OFFICE OF THE CHIEF OF ENGINEERS
VALUE ENGINEERING STUDY TEAM

VALUE ENGINEERING STUDY SUMMARY REPORT

ROBLES DIVERSION PROJECT ***Ventura River Basin, CA***

June 2007

2005 Aerial View of Robles Diversion

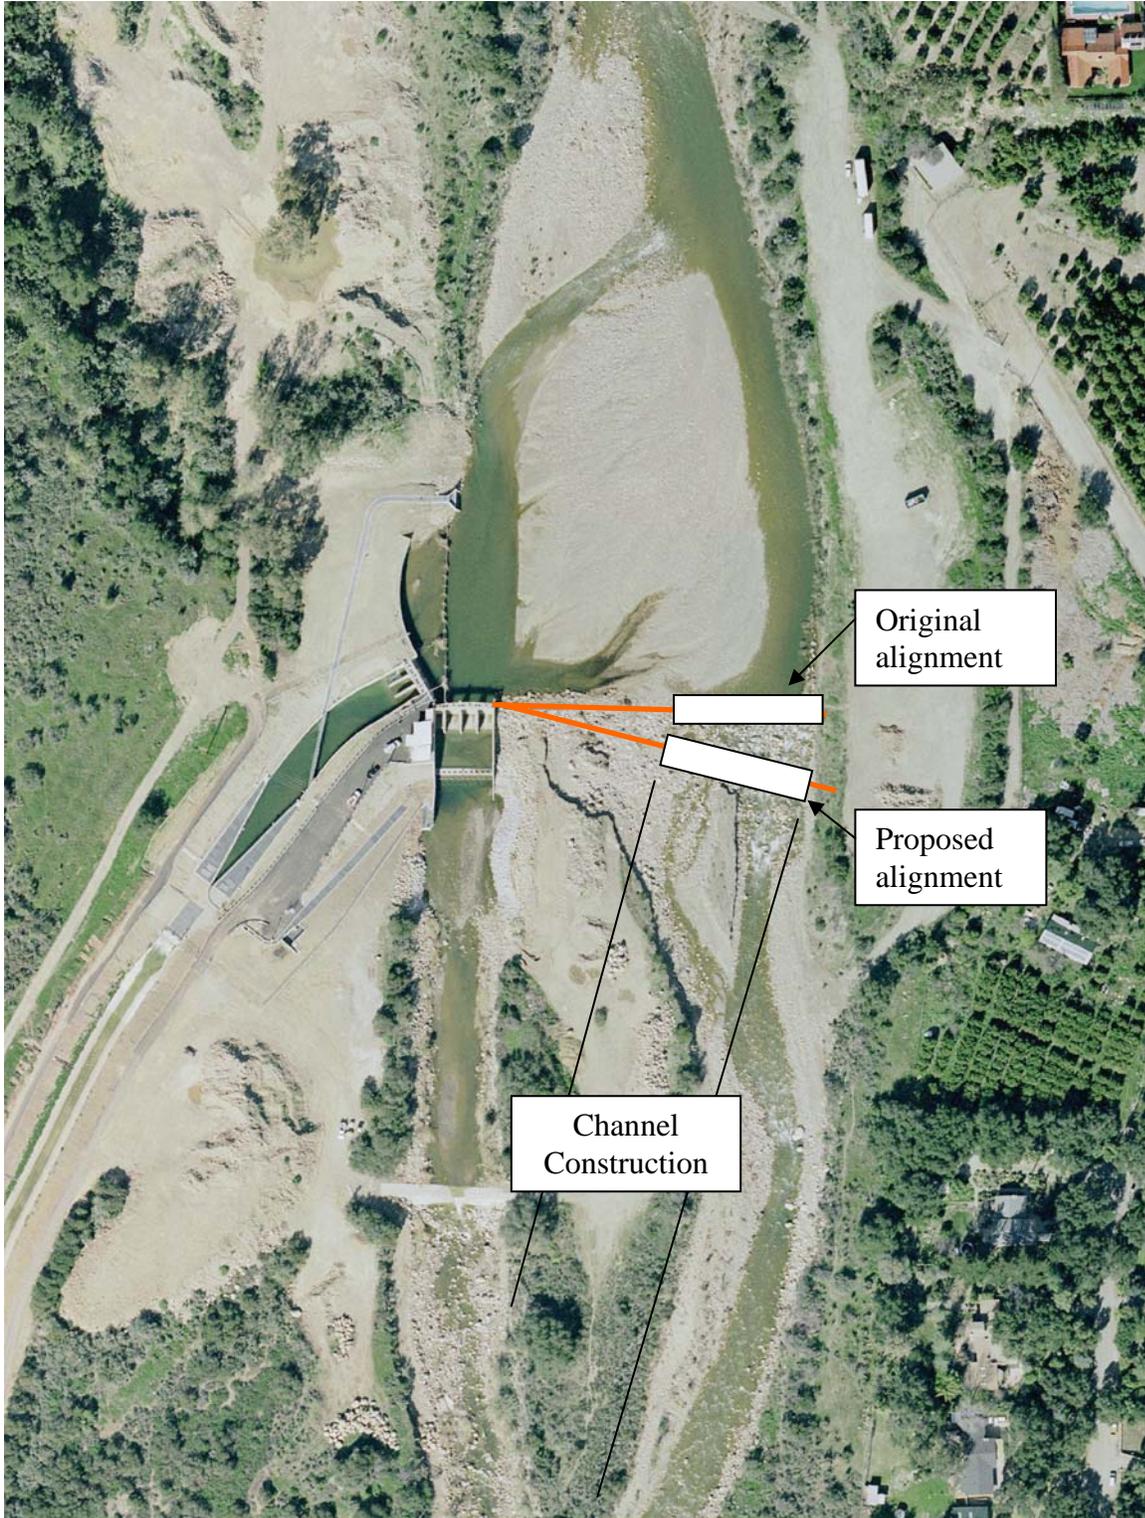
ORIGINAL DESIGN: The original Alternative 1 design proposed in the Matilija Feasibility Report called for the radial gates on the East side of the channel. The gates would be oriented the same as the existing radial gates on the West side.

PROPOSED DESIGN: The alignment of the gates and embankment would be rotated in the downstream direction approximately 10 to 15 degrees.

- The flows may be more favorable for sediment sluicing because of increased downstream slope. The increased slope will allow flows to transport more sediment while preserving control of water surface elevations in basin.
- The distance from the diversion to the confluence will be shortened.
- The size of the cutoff wall can be reduced.
- Maintains natural high flow alignment of river.
- Increased sediment sluicing increases diversion reliability.
- It will re-direct flows away from the toe of the levee.

- The crest length will have to be increased.
- There is a risk of split flow within the basin, limiting the amount of diversion.
- May require additional channel maintenance and or bank protection on the West side of the river.
- May intersect with downstream fish passage weirs in the west channel

Plan View

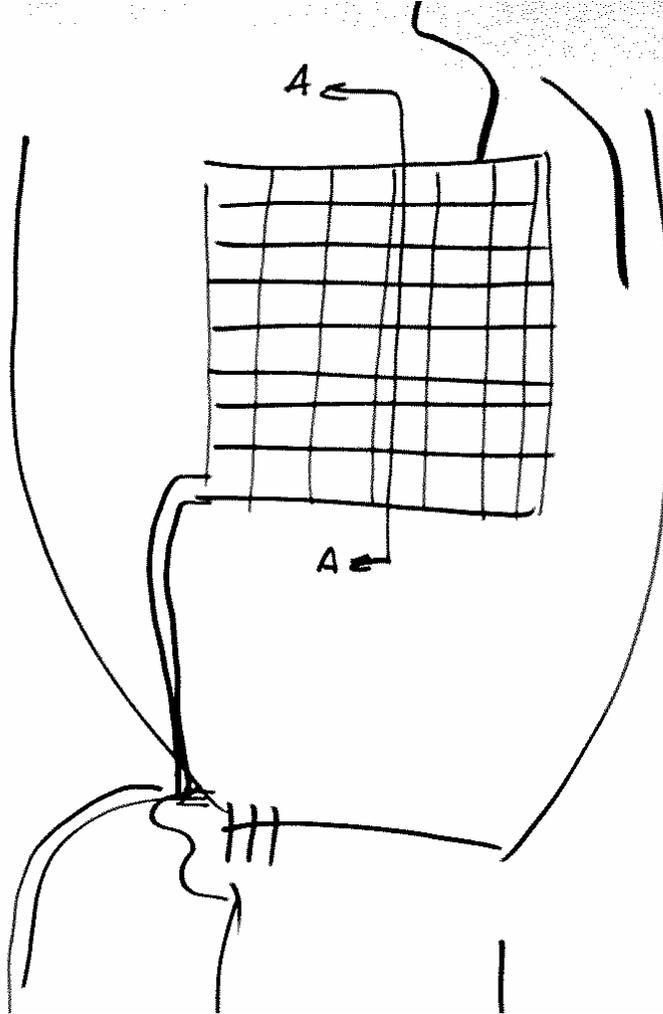
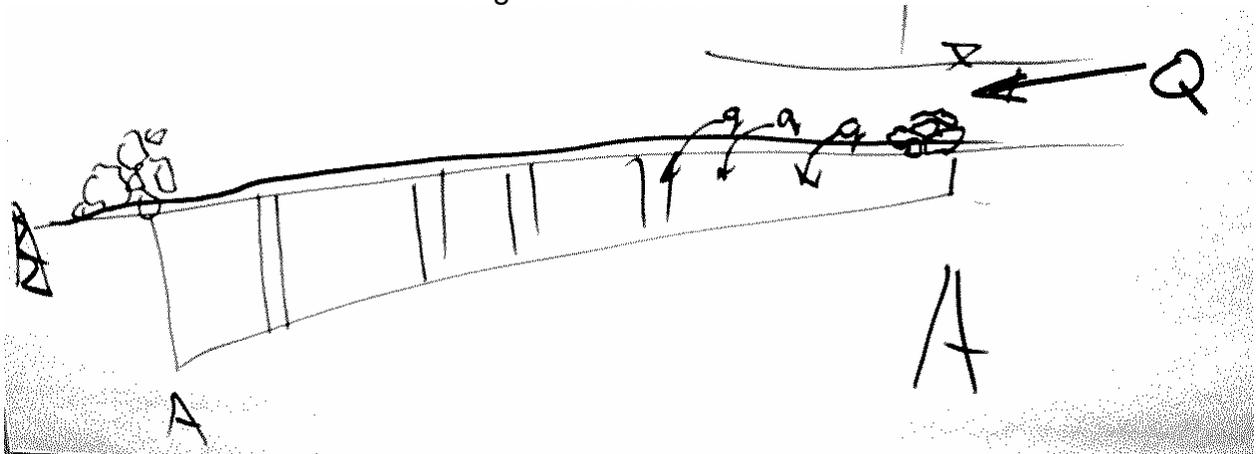
PROPOSED DESIGN:

The concept includes an underground basin to collect water below the surface. The basin would be topped by a concrete waffle slab that supports natural stone, rocks, and cobbles and would have to be designed to allow for additional sediment deposition as we anticipate continued to aggradation in this area. The slab holes would be designed to allow for adequate flow so that the 500 cfs, required diversion, would be maintained plus any safety factor and required diversion down the fish passage. The basin would have sufficient size to allow for the periodic cleanout of sediments and other maintenance (including the waffle slab). The water would flow to the diversion structure through piping using gravity and/or pumps. Water and sediment flows in excess of the designed level would simply pass over the structure. An operation assumption requires the basin to be full of water prior to any diversion down the canal to Lake Casitas and flows exceeding 50 cfs.

The proposed concept includes a system to collect water and move it to the diversion and fish passage facility while minimizing the need for any additional surface structure. This could allow sediment to flow relatively unimpeded, bypassing the existing Robles facility. It would add to the “natural” environment as there would be limited structures above ground.

Olmsted Wicket

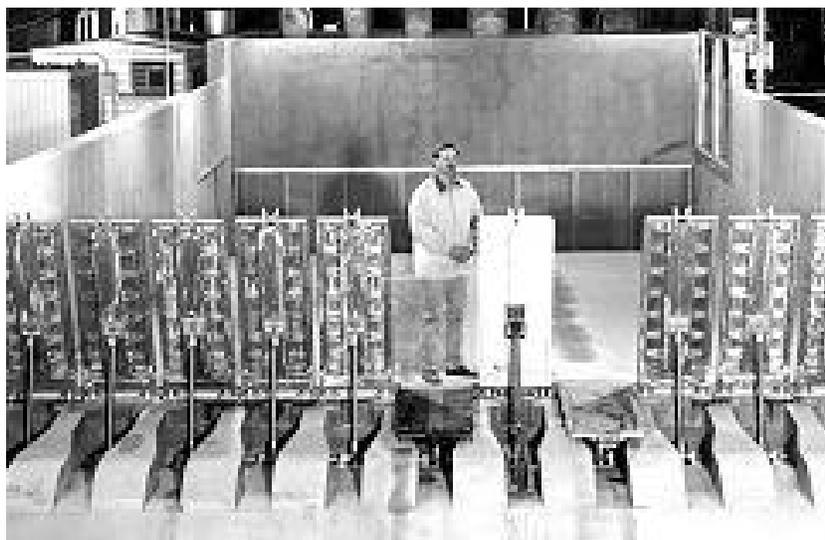
PROPOSED DESIGN:

Use a multiple wicket design in lieu of Obermeyer. Steel wickets, hinged on the upstream end at a fixed invert would be placed in approximately in the same location as the Obermeyer. The wickets would operate in the up position potentially for years at a time and would be dropped prior to major events (or potentially forecast events) that would exceed the design capacity of the existing structure (7,000 cfs). Following major storm events, wickets would be reset in the up position using portable equipment such as back hoes or through the use of cables.

JUSTIFICATION: The complexities and uncertainties associated with an Obermeyer make it an unreliable option in this application. It would perform much better in applications where it is operated up and down relatively frequently. The flexibility and simplicity of the wicket system will allow it to operate reliably and cheaply for years. If compared to the radial gates, the advantage is primarily cost, as it is significantly cheaper for initial construction and has lower maintenance costs.
